**3GPP TSG_CN
Plenary Meeting #9, Oahu, Hawaii
20th – 22nd September 2000.**

Tdoc NP-000544

Title: CRs to R00 Work Item Technical Enhancements and Improvements (TEI)

Subject: Correction to MSC-A handover SDLs

Figure 19.2.2/1 (sheet 8 of 13): Process MSC_A_HO

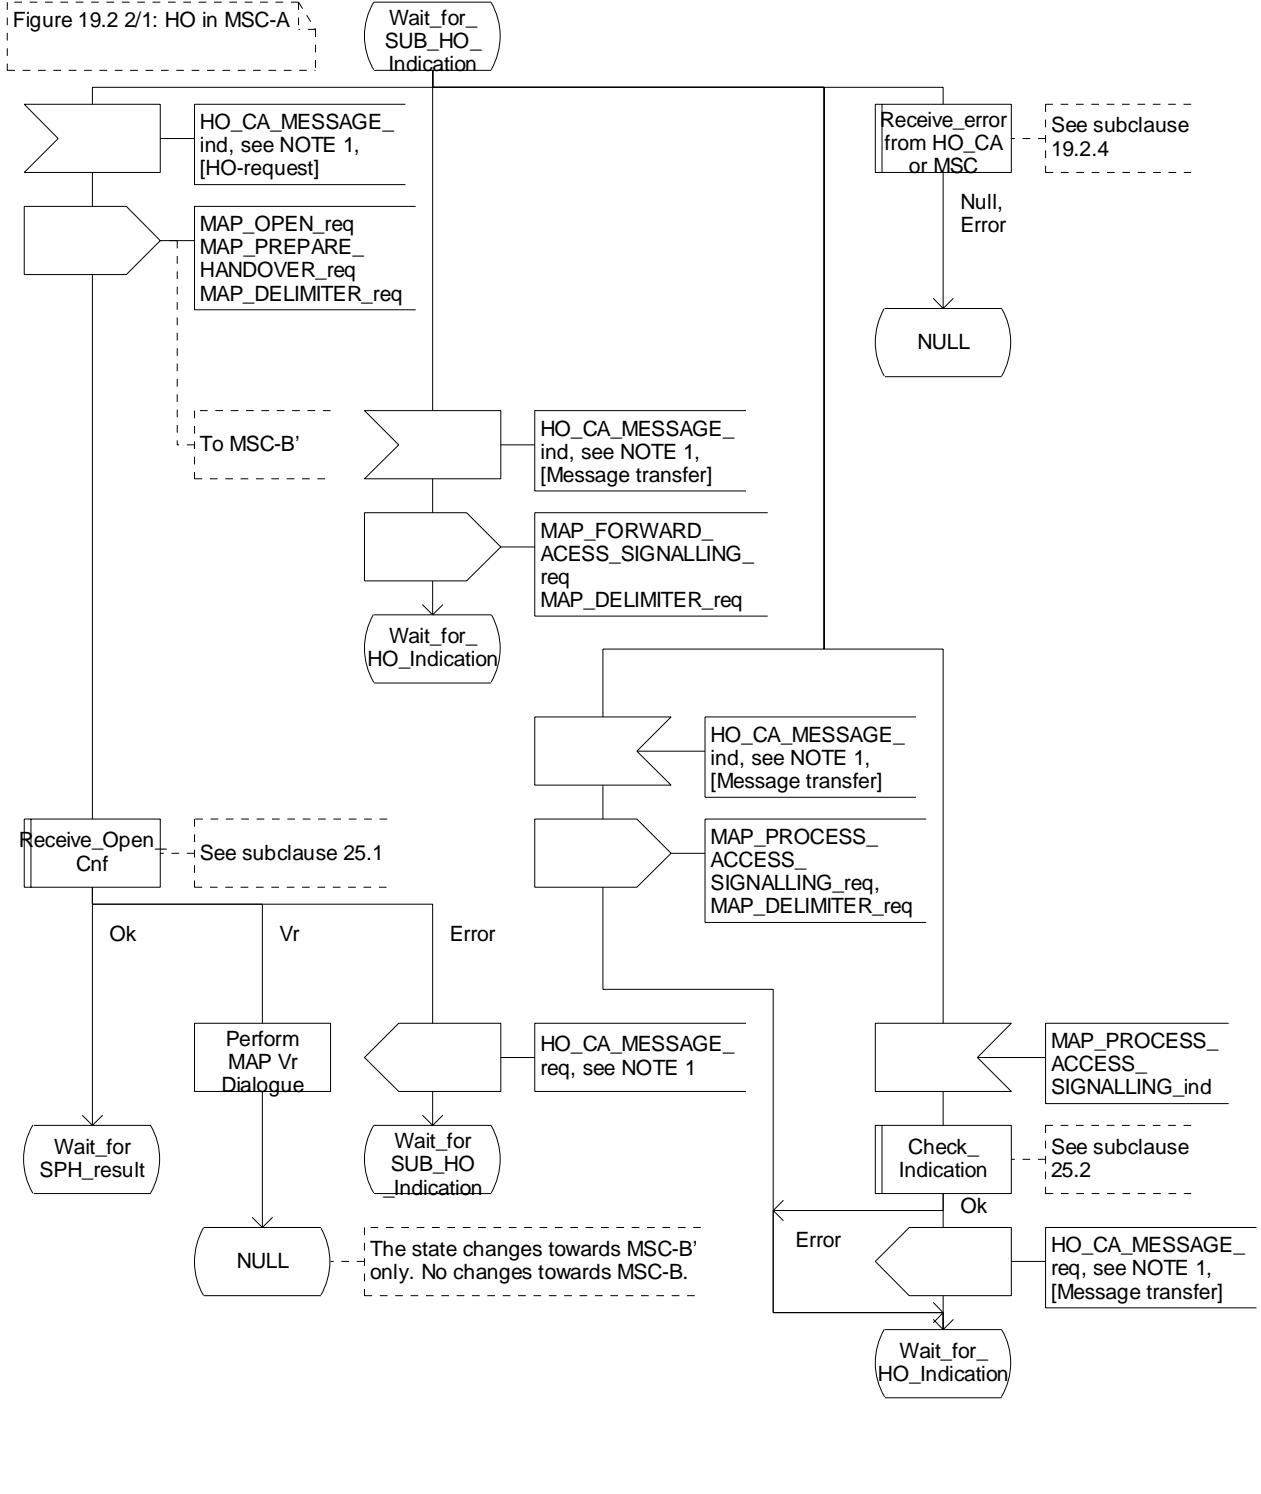
- The new figure 19.2.2/1 (sheet 8 of 13) seems to represent more than just editorial changes (as indicated by CR 143 coversheet)
- Replaced MAP_Prepare_Subsequent_Handover respond by MAP_forward_access_signalling Request
- Replaced Call on MSC-B by Wait_for_HO_indication
- Replaced Wait_for sub_ho_indication by Wait_for_Ho_indication

Figure 19.2.2/1 (sheet 8 of 13): Process MSC_A_HO

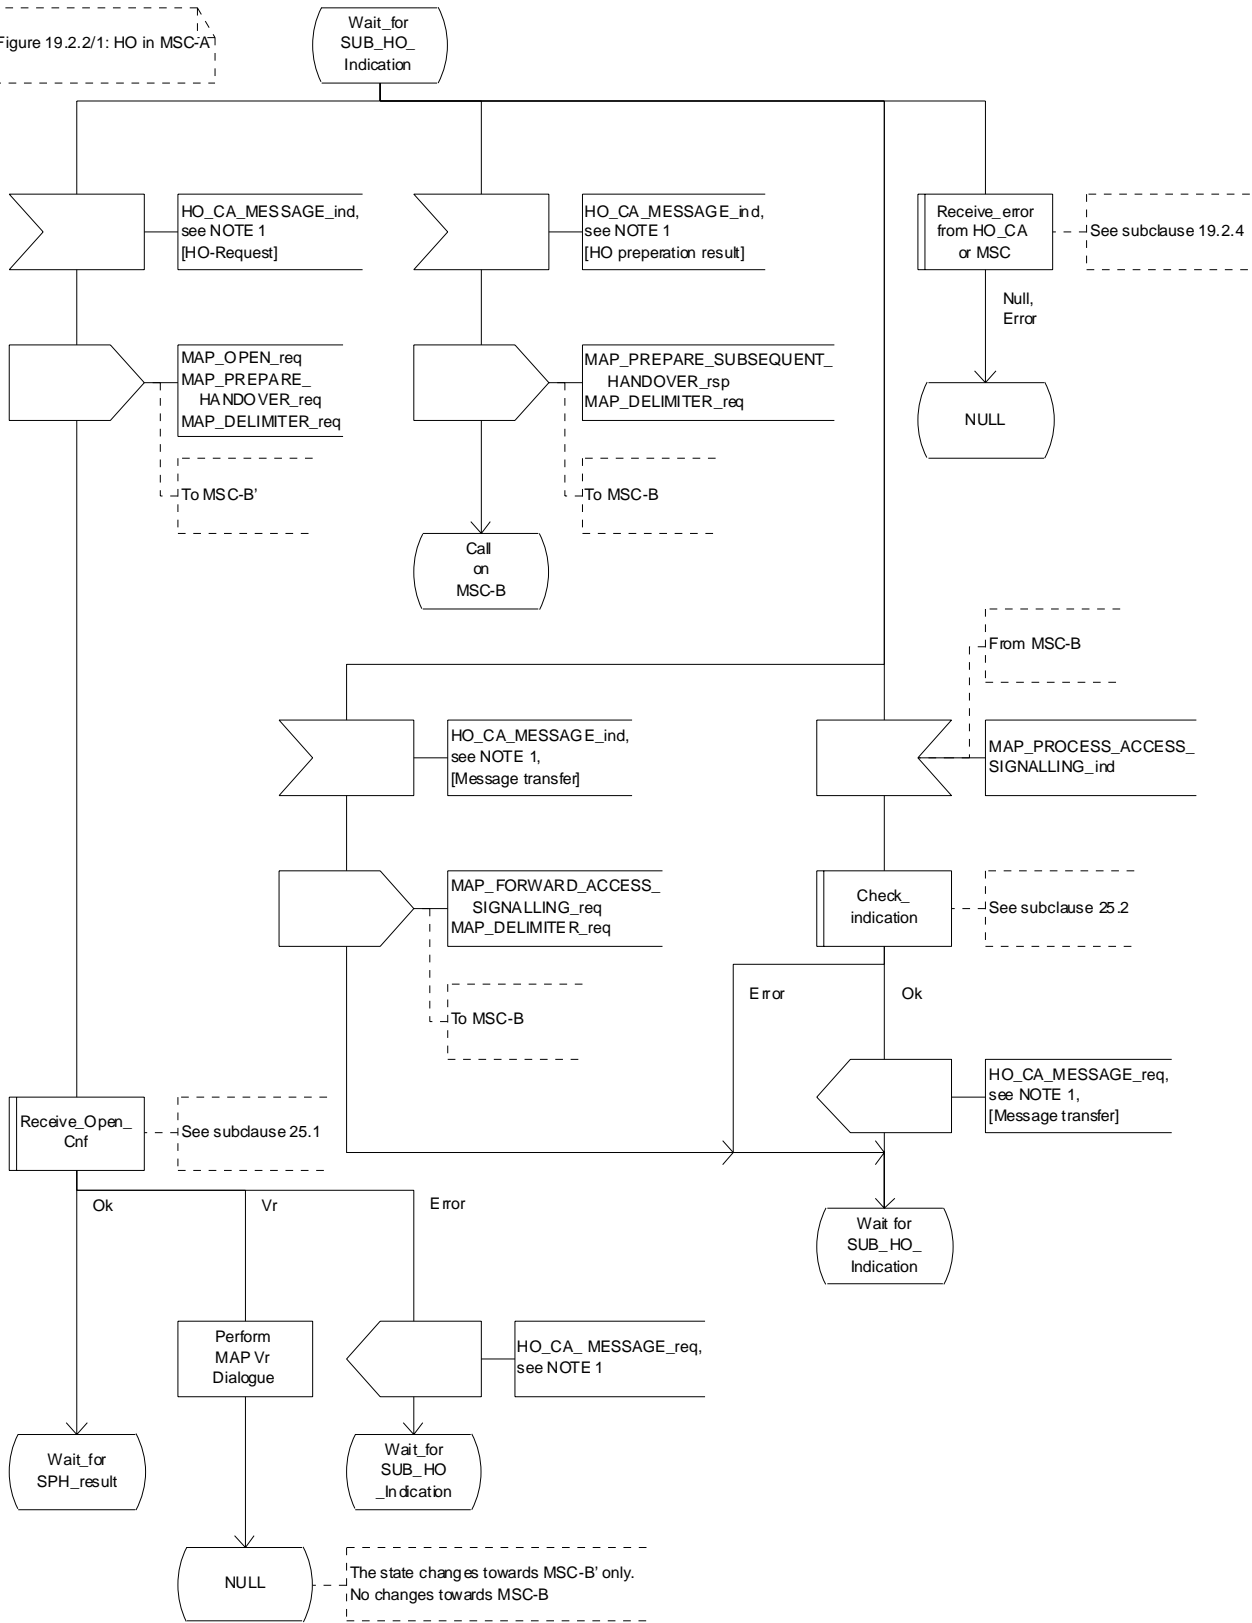
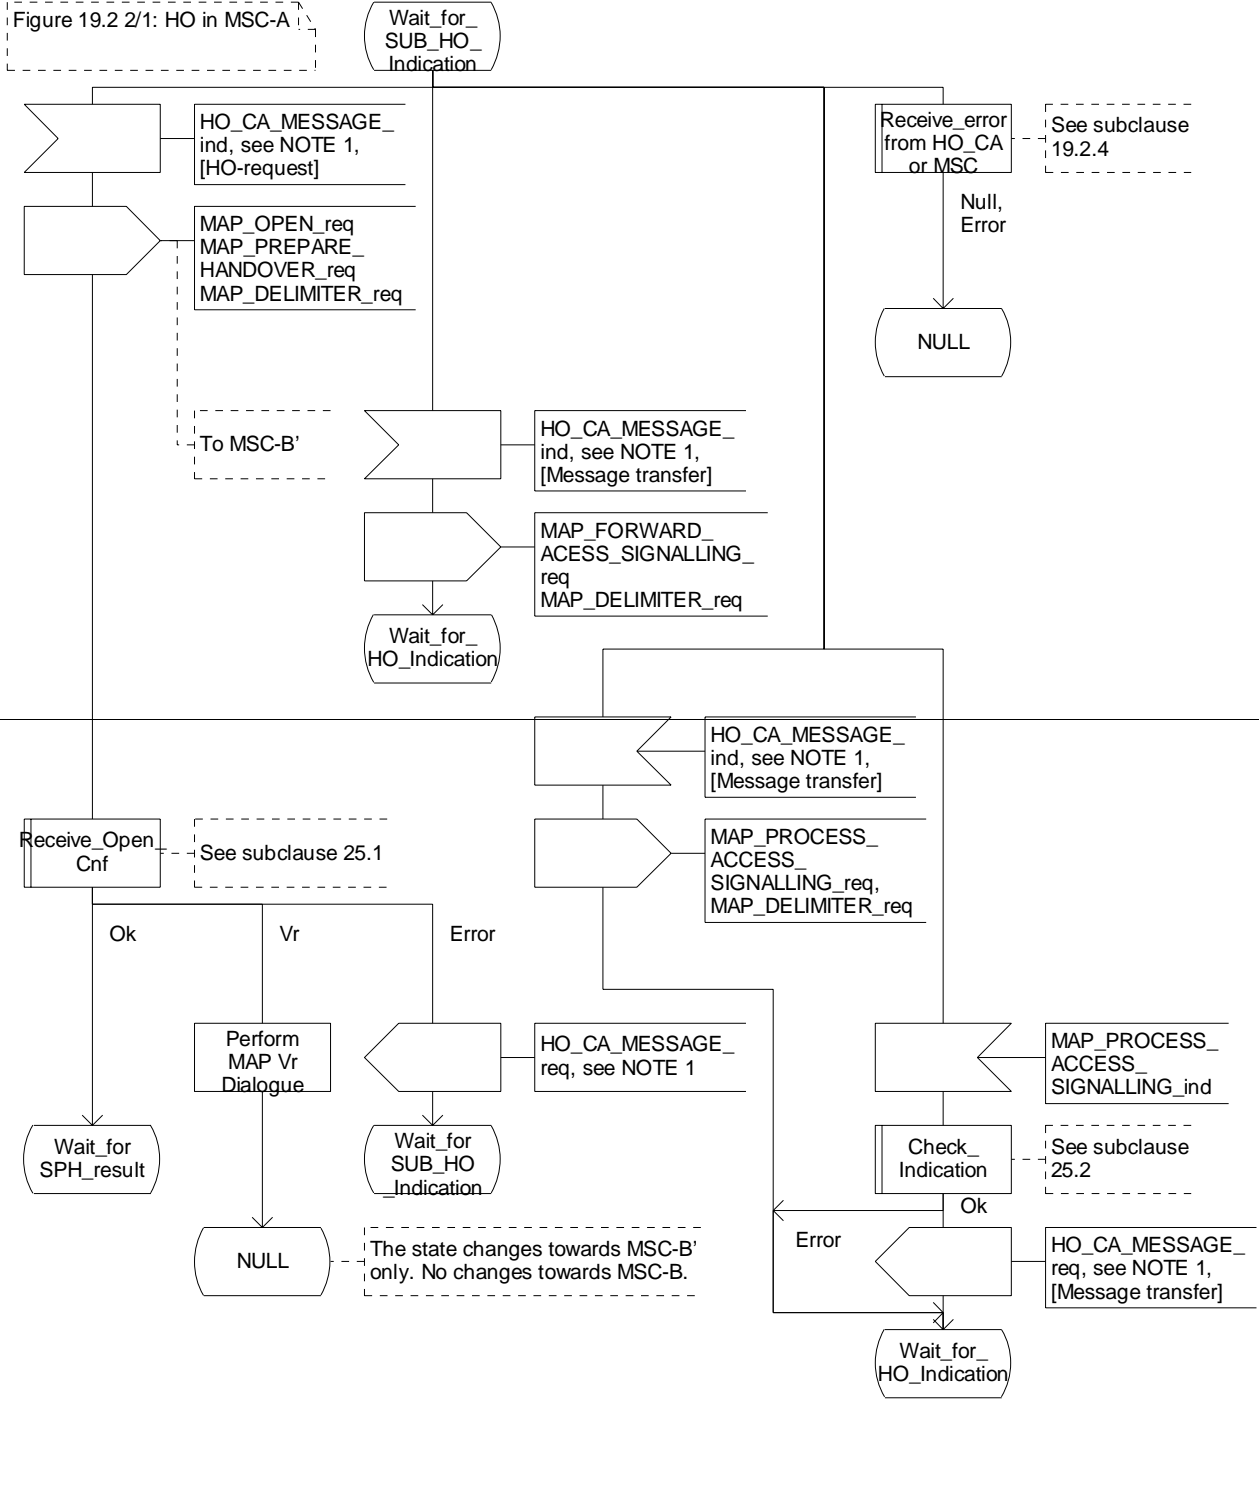
Other comments: Header for sheet 8 needs changing 19.2.2_1.7(12) -> 19.2.2_1.8(13)
